Hi-Fi Products
Service Bulletin

Model: TC-V11, TC-V33

No. 192

Subject: Incorrect Reference Number in
Service Manual - Reference # 130

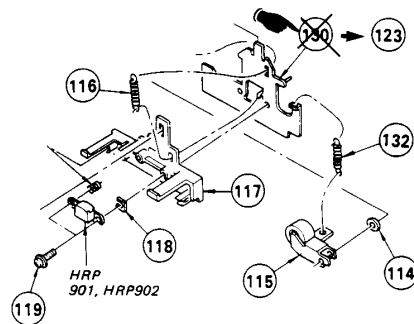
Symptom: The Head Chassis (S) assy is incorrectly shown as reference
(**) # 130 on page 26 of the Service Manual.

Solution: Make the following correction in the Service Manual.
